2017 West Coast Airspace Review

Summary of Submissions

As outlined in the CAA 2015-2018 Airspace Review Plan document, airspace over the West Coast of the South Island is under review with changes to be effective 9 November 2017.

Figure 1 – NZA740

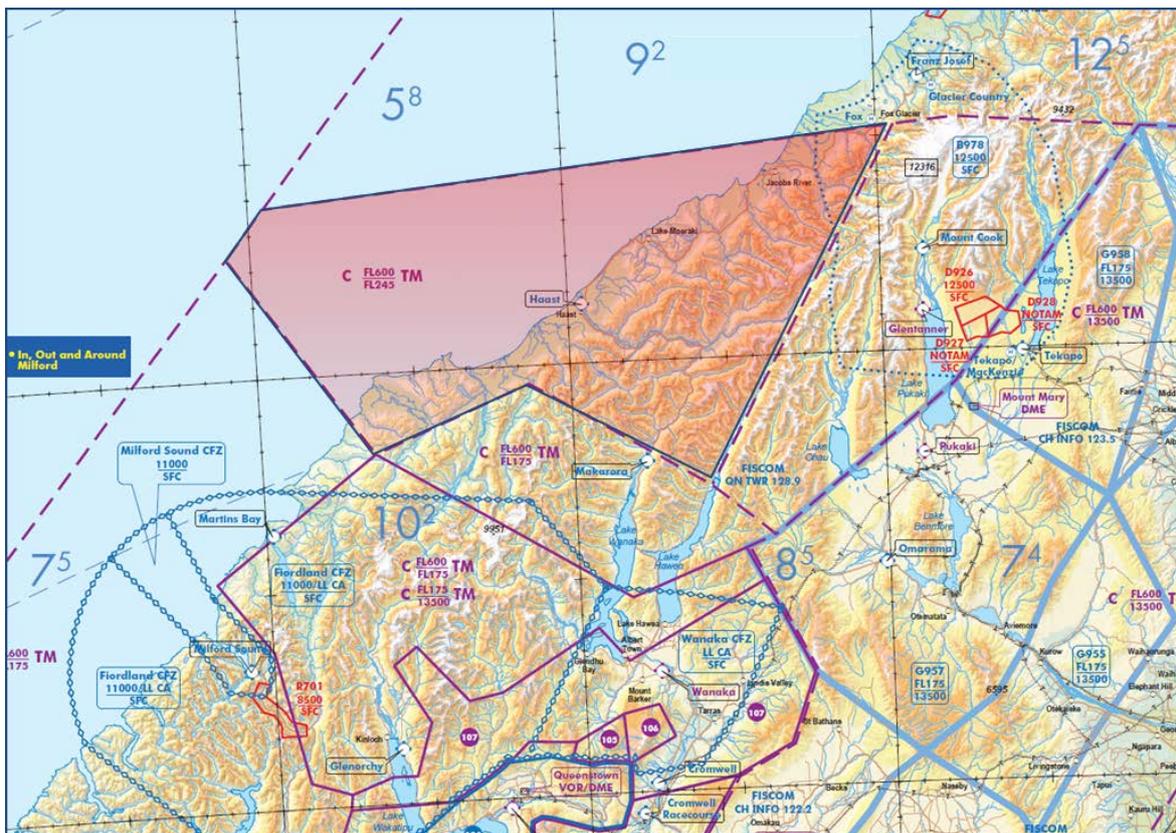
Airways submitted a petition to amend the lower level of controlled airspace NZA740, between Fox Glacier and south of Barn Bay, from FL245 to FL175. This would align with NZA948 to share a common lower limit of FL175.

NZA740 is the area shaded in red in Figure 1 below.

1. *Allow turbo-prop traffic to transit in and out of Queenstown Aerodrome west of Mt. Cook whilst remaining in controlled airspace, on routes Y320 and Y569.*
2. *Enable an alternative routing for turbo-prop traffic for weather avoidance, remaining in controlled airspace on routes Y320 and Y569.*

3. Lowering the controlled airspace would make it consistent with the Christchurch CTA/C NZA948 (above the Queenstown CTA/C). Consistency leaves less room for error.
4. Enables a better climb profile for traffic departing Queenstown tracking via Y569.
5. Traffic can be vectored above FL180 (currently FL250) for weather avoidance.
6. Traffic can be vectored above FL180 (currently FL250) for ATM and sequencing into Queenstown.'

Figure 2 – Southern Alps MBZ amended eastern boundary

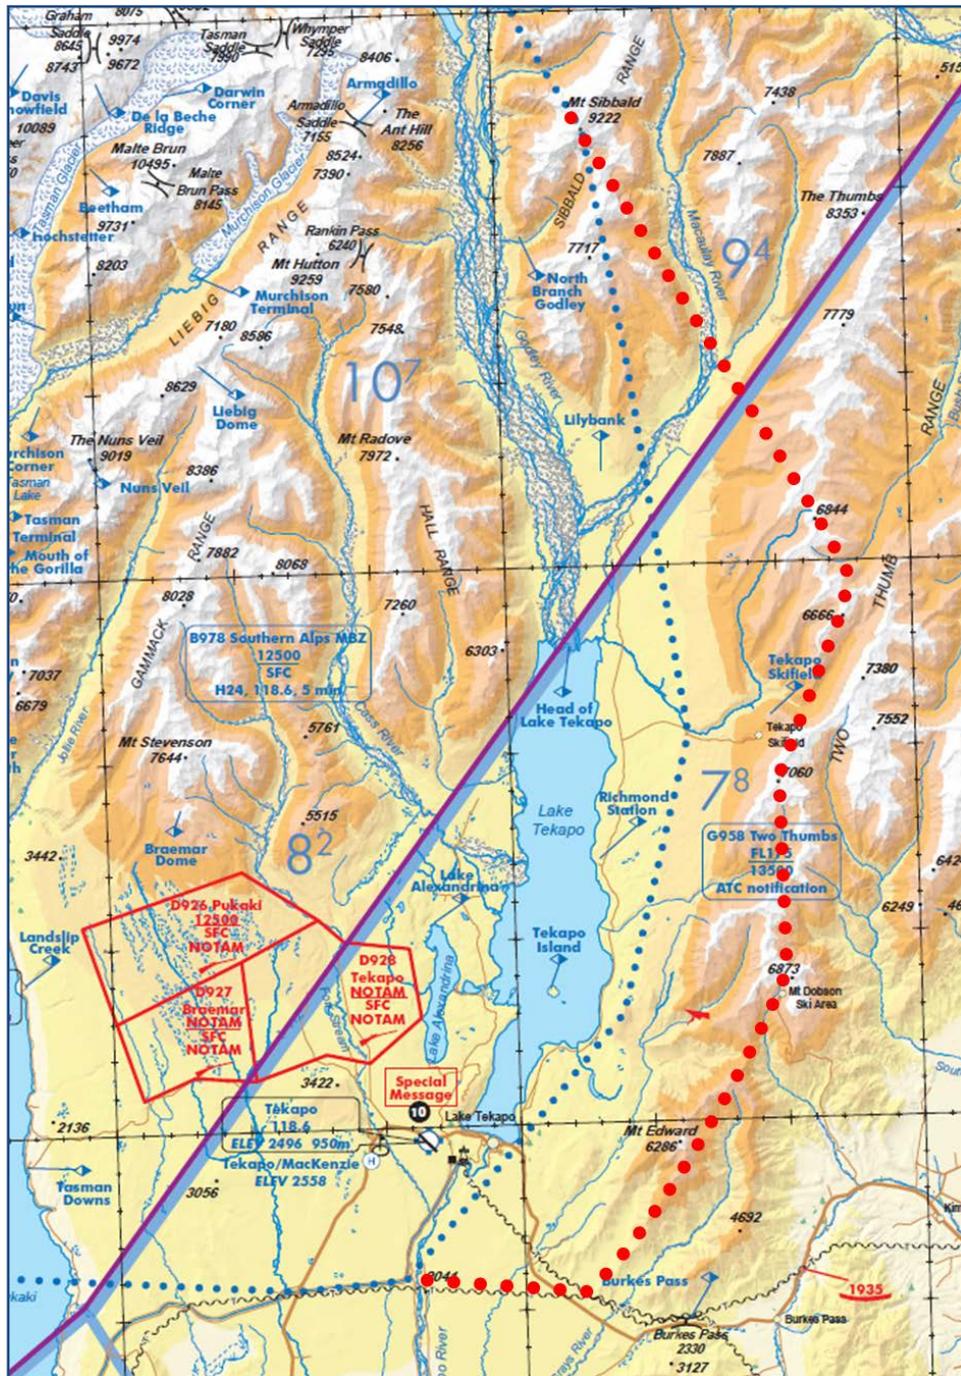
The proposal is to extend the eastern boundary to along the ridge of the Two Thumb Range. The reasons stated are:

'This is a natural barrier to Mackenzie basin from the east and is more defined boundary than the current one. The main purpose however is as a safety barrier for the flights operating at Tekapo aerodrome and Mackenzie heliport. Currently aircraft using runway 11 for departure and landing on runway 29 at Tekapo leave the boundary on an extended circuit around the village (for noise purposes) potentially causing conflict by other aircraft skirting the boundary not using the MBZ frequency. Helicopters also frequently land in Tekapo Skifield, Mt Dobson Skifield and other locations on the western side of the Two Thumb Mountains and it is better for these aircraft to remain on the MBZ frequency for situational awareness inside the MBZ, the usual departure point for helicopters landing in this area.'

The amended boundary shown by the red dotted line in Figure 2.

Figure 3 – Southern Alps MBZ south-western boundary amendment

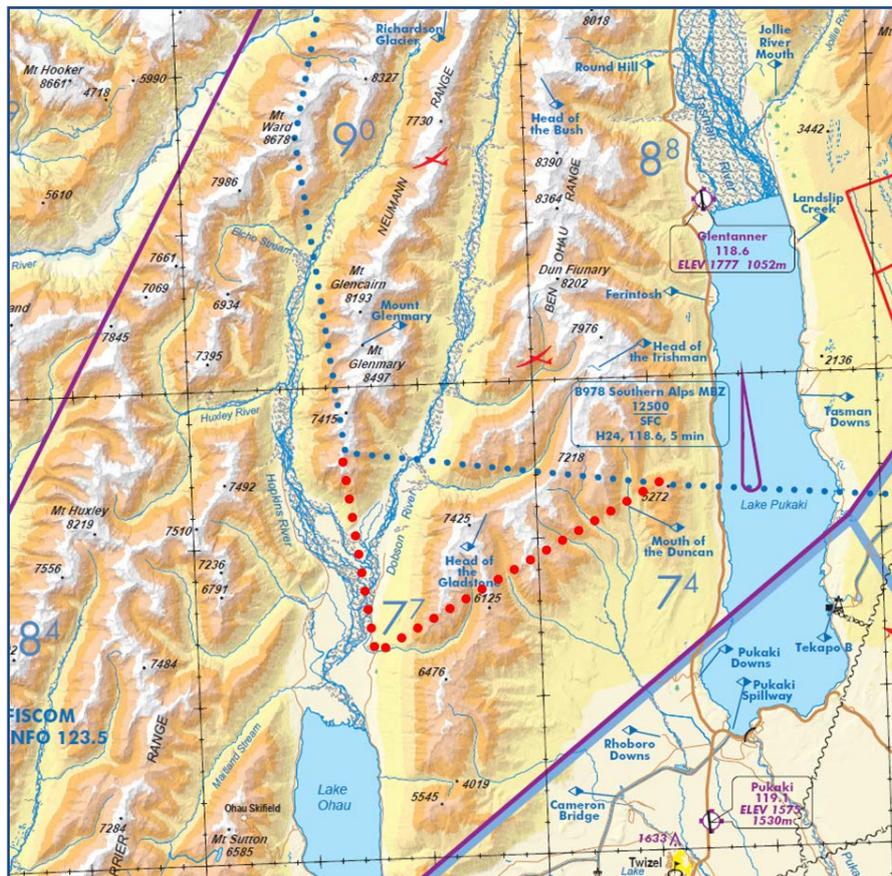
It is proposed to extend the south-western boundary corner out to encompass most of the Gladstone Valley, particularly the Gladstone Saddle. The purpose of the change is to ensure that northbound gliders from Omarama and aircraft departing from Pukaki tracking north-west through the Gladstone Saddle are on the same frequency.

The amended boundary is shown by the red dotted line in Figure 3.

Figure 4 – requested VRPs

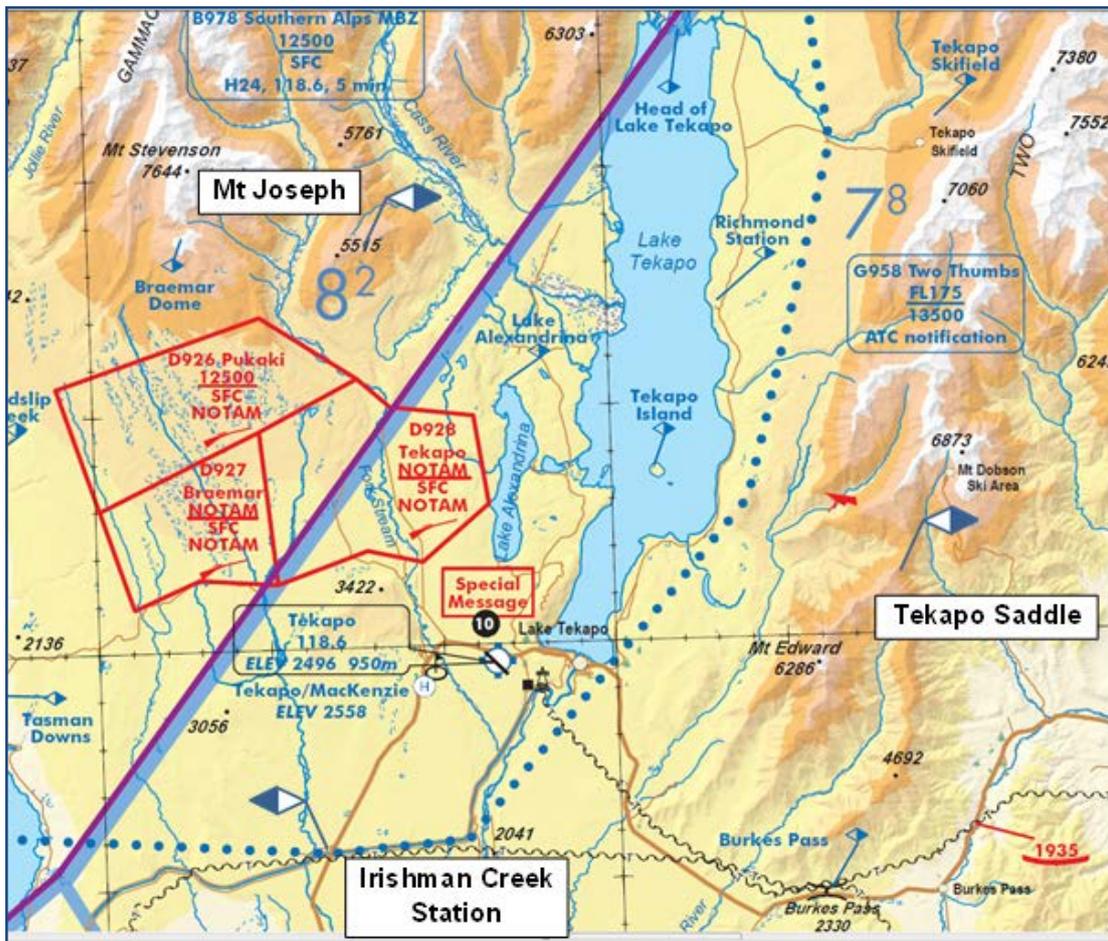
The Mount Cook and Westland National Parks User Group has requested the designation of three new visual reporting points (VRP). The VRP are located at commonly used points used by local operators.

'It is a natural change-over point from east to west (and vice-versa) for aircraft entering the Mackenzie basin on a track Christchurch to Tekapo and used reasonably frequently due to the low defined saddle. It will also become a perfect boundary point with the proposed MBZ boundary extension (our other attached application).'

'Used very frequently on a daily basis by both Tekapo based operators on all their standard flight paths. Has come to a point where itinerant aircraft have repeatedly specifically asked where it is due to the frequency of use.'

'Another commonly used reporting point by Tekapo based operators when tracking between the Tekapo area and Twizel/Pukaki airport. An identifiable point located beside the canal bridge that will make perfect entry point into the MBZ from the south for itinerant aircraft too.'

Figure 5 – Hokitika MBZ proposed amendment plan view

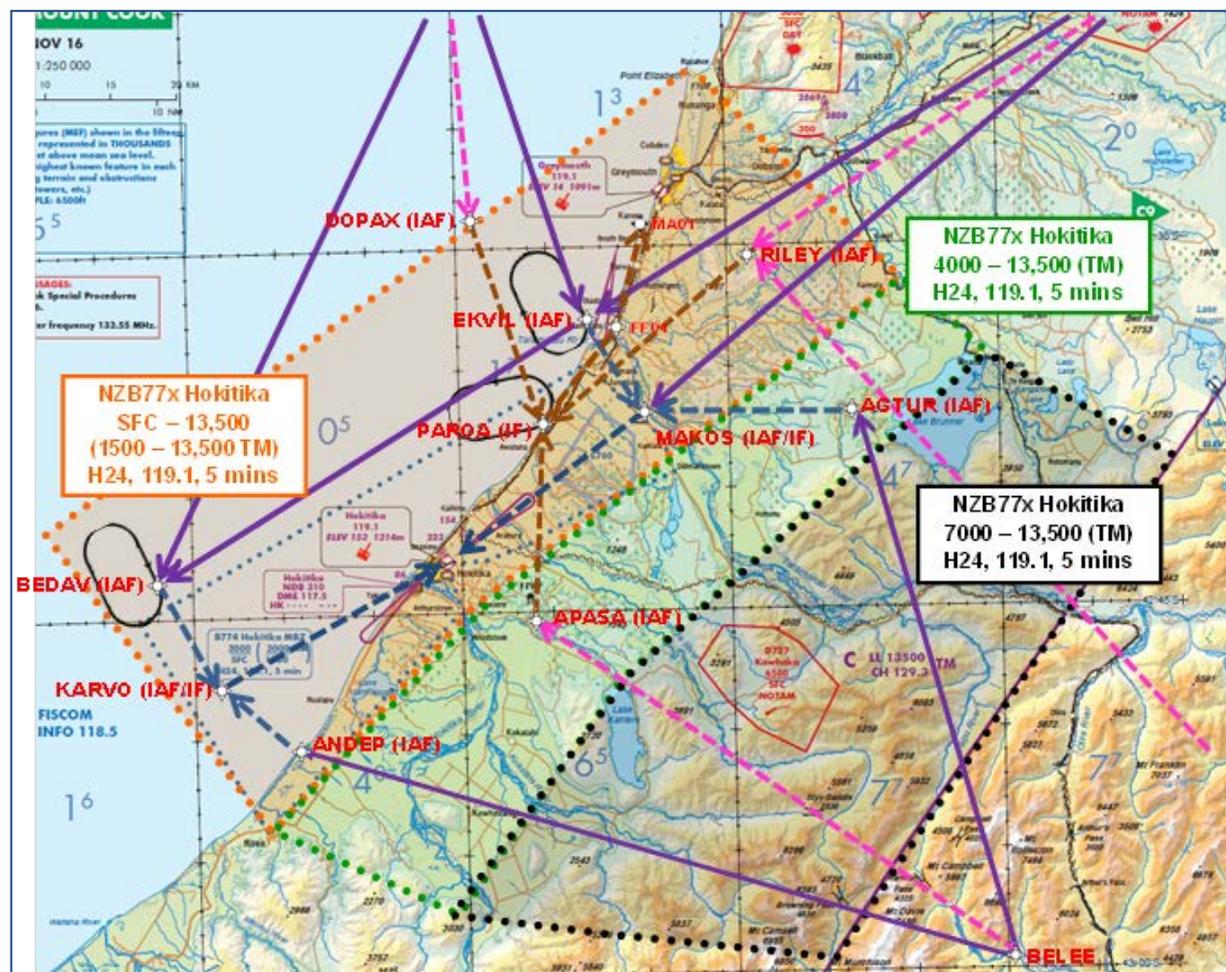
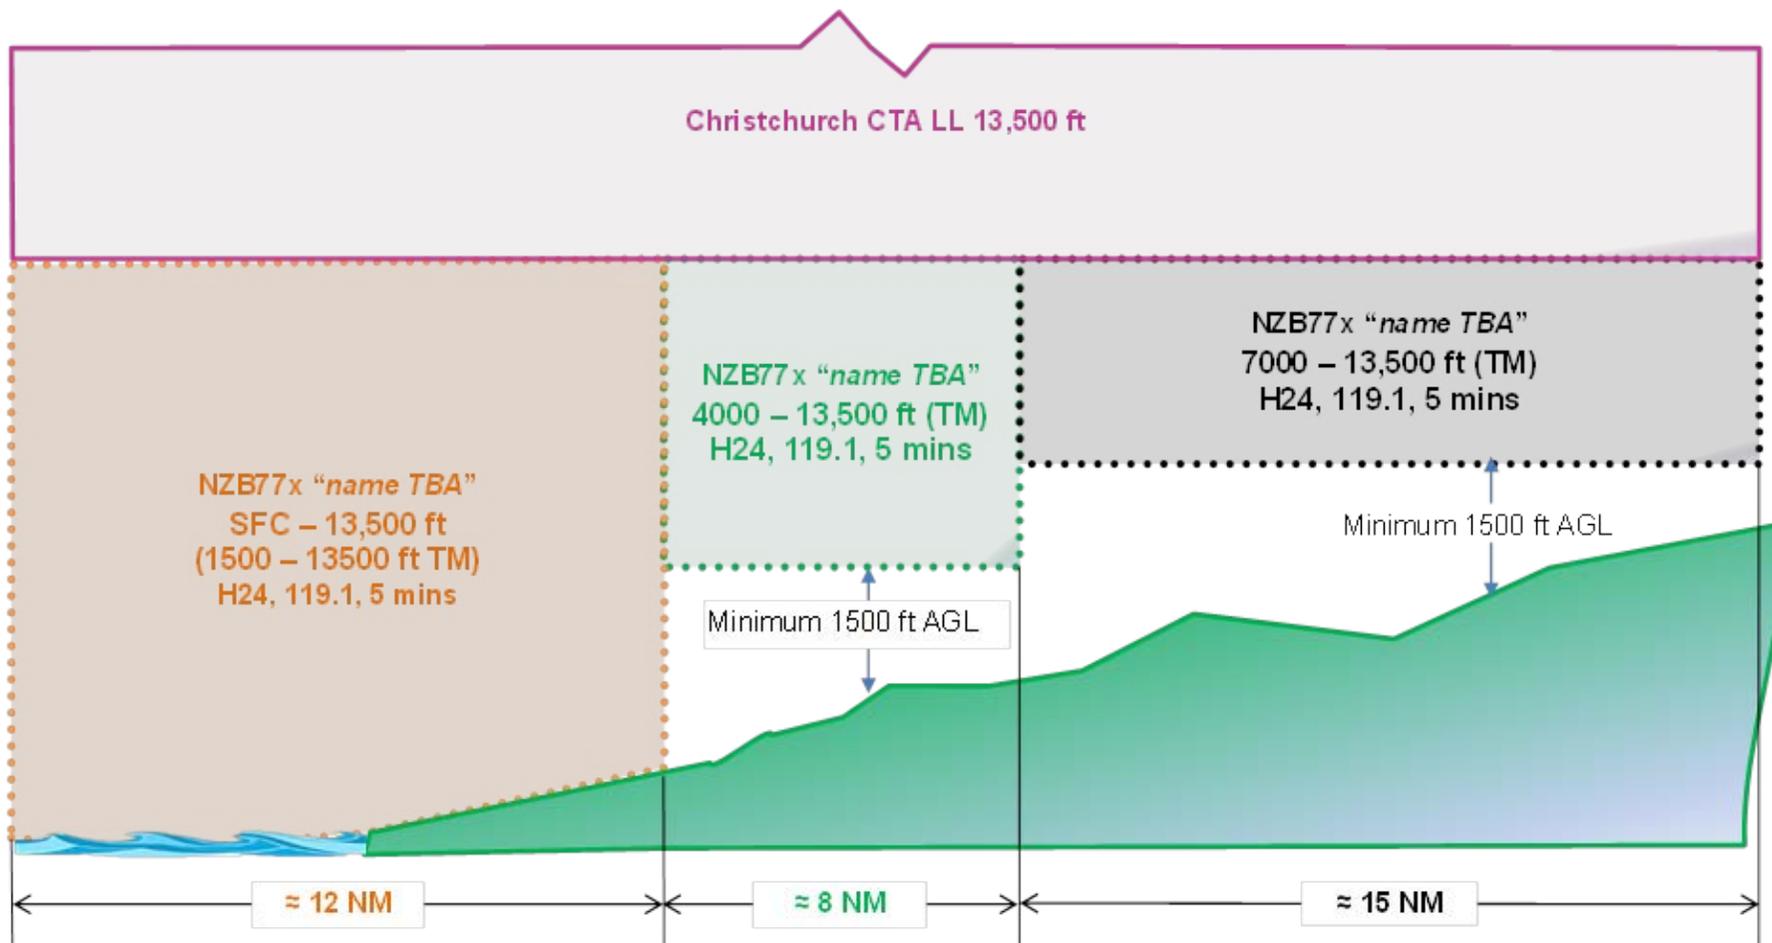
Refer to Appendix A – Figures 5 and 6 for diagrams of the requested airspace.

Air Nelson submitted a petition to extend the boundaries of NZB774 for the following reasons:

- Increased number of IFR corporate and air ambulance flights, as well as VFR aeroplane and helicopter traffic.
- Proximity of Hokitika and Greymouth aerodromes with RNAV IFR procedures overlapping. While the aerodromes share a common frequency of 119.1 MHz, Hokitika is within the MBZ, but Greymouth is not.
- Hokitika MBZ does not fully encompass the RNAV arrivals and approaches for both aerodromes.
- Air Nelson is concerned that IFR traffic for both Greymouth and Hokitika may encounter VFR traffic during the arrival procedures that may not be using a radio or transponder.

The proposal is to have a common MBZ encompassing both Hokitika and Greymouth aerodromes and include the arrival, approach, hold and departure procedures for both aerodromes.

- (i) A normal descent profile of 300 ft per NM up to the lower limit of controlled airspace – 13,500 ft.
- (ii) Enable flight crews to monitor only one other frequency (the MBZ frequency) prior to leaving controlled airspace.
- (iii) Air Nelson provided the following rationale for the eastern boundaries and the upper limit:

"The boundaries of the tiered MBZ to the East are a little hard to geographically define. However we have attempted to one, give a reasonable buffer between the arrival/departure tracks and profile altitudes, and two, lining up or close to reasonably prominent geographical features.."

The rational [sic] for extending the MBZ upper limit to the LLCA 13,500ft is that the high en-route MSAs and weather or other traffic arriving and departing can often necessitate either staying at or climbing to cruise altitudes to the West of the main divide."

The current frequency is the unattended aerodrome frequency 119.1 MHz. Due to the topography of the West Coast, when operating at lower levels, this would not be an issue with other unattended aerodromes. However, at higher altitudes there is the potential for the frequency to become cluttered by receiving transmissions from all over the country.

At present pilots are required to report every five minutes inside the MBZ. This is not onerous in a small MBZ of approximately 20 NM by 6 NM (120 NM²), as it equates to normal reporting intervals when operating within the vicinity of an aerodrome. If the MBZ is extended in size, it will become approximately 35 NM by 30 NM (1050 NM²).

Any transponder mandatory airspace lower limit would be set at a minimum of 1500 ft AGL for if the MBZ is amended.
